City of Detroit  
Inter-Departmental Communication

**RE:** Petition No. 283  
Requested Encroachment at Portion Of Orleans Street And Dequindre Street In  
The Area Bound By Superior, Riopelle, Canfield, And Dequindre.

## **PROVISIONS FOR ENCROACHMENT For Petition 283**

JOB NO. 01-01  
 DRWG. NO. X 283

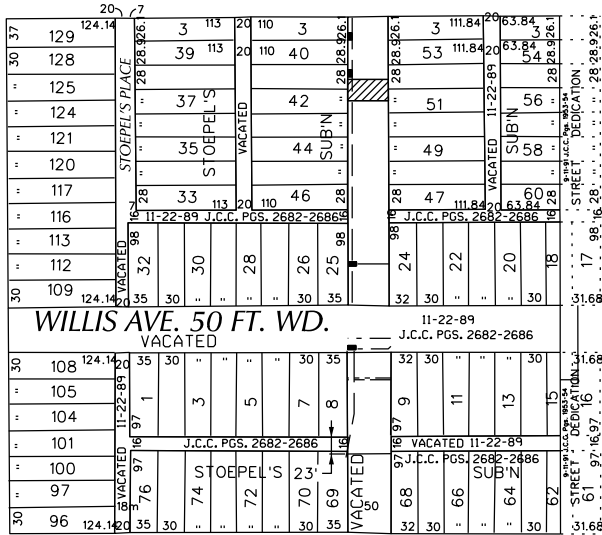
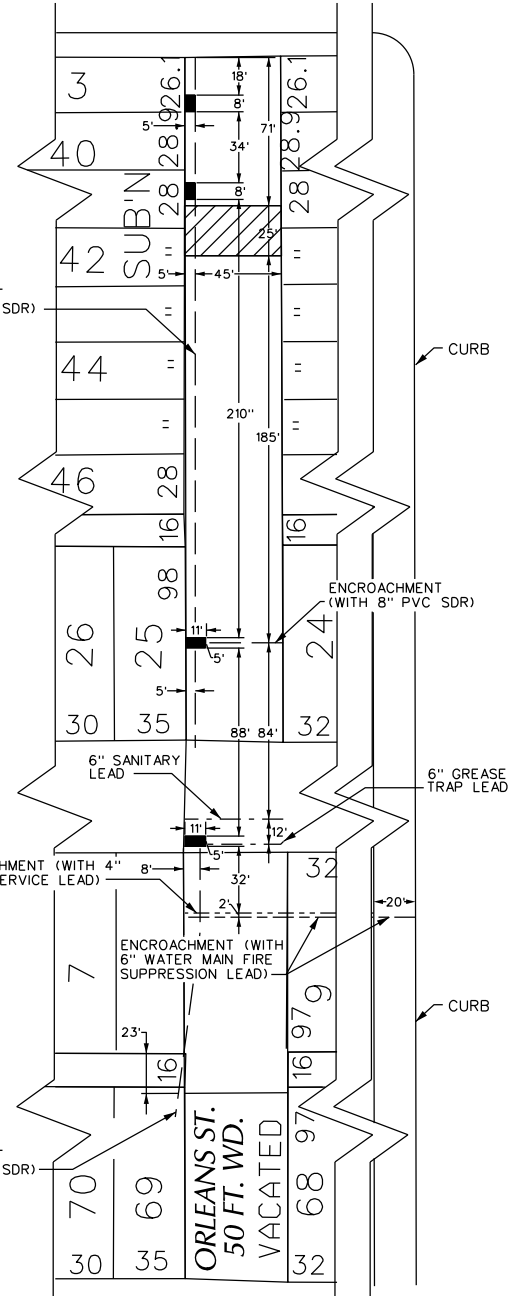
- DWSD has no objections to the requested encroachments provided the petitioner will remove the proposed ramps or stair wells due to any DWSD repairs or required maintenance and that the attached Provisions for Encroachment are strictly followed.
